1 **Appendix 1A**

2 **Comments from Federal Agencies and**
 3 **Responses**

Re: Cooperating Agency Review of the Draft Environmental Impact Statement for the
Coordinated Long-term Operation of the Central Valley Project and State Water Project

Figure 1. Summer Townet Survey Age-0 Delta Smelt Abundance Indices, 1959-2014

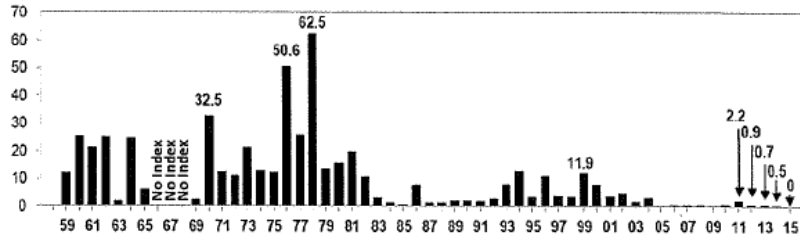
Populations of all the species covered by the 2008 Fish and Wildlife Service and 2009 National Marine Fisheries Service Biological Opinions (BOs), as well as several non-listed resident and migratory fishes, have continued to decline since the BOs were finalized. For example, the 2015 summer townet survey for Delta smelt recorded a zero juvenile Delta smelt abundance index.²

The continued decline of resident and migratory fish populations suggests that the suite of Reasonable and Prudent Alternatives implemented to date, plus commitments¹ to improve protection for aquatic habitat in the San Francisco estuary watershed, have not yet been successful in protecting aquatic habitat, reversing population declines, actually avoiding jeopardy, and/or improving aquatic life beneficial use protection. The pace and severity of the decline highlight the urgent need to move forward with full implementation of the RPAs and, perhaps, additional measures in an adaptive management context to ensure their effectiveness. Alternatives 1, 2, 3 and 4 would discontinue implementation, or would only selectively implement, the Reasonable and Prudent Alternative (RPA) actions identified in the BOs, which are designed to improve riverine and estuarine aquatic habitat to avoid jeopardizing the existence of multiple threatened and endangered species. The DEIS fish analysis for Delta smelt and longfin smelt show that Alternatives 1, 3 and 4 would result in adverse impacts to these species relative to the No Action Alternative. Discontinuation of RPA actions is likely to also negatively impact non-listed fishes that benefit from improved aquatic habitat conditions the RPAs provide. Full

34 **EPA 6:** It is acknowledged that the condition of aquatic resources has deteriorated
35 over the past 7 years and it is likely that the current drought in California has
36 undoubtedly resulted in profound effects on aquatic resources, especially on those
37 species with already declining populations. Both the drought and the resultant
38 management actions have contributed to this condition. A brief discussion of the
39 current drought has been added to Section 9.3 of Chapter 9, Fish and Aquatic
40 Resources.
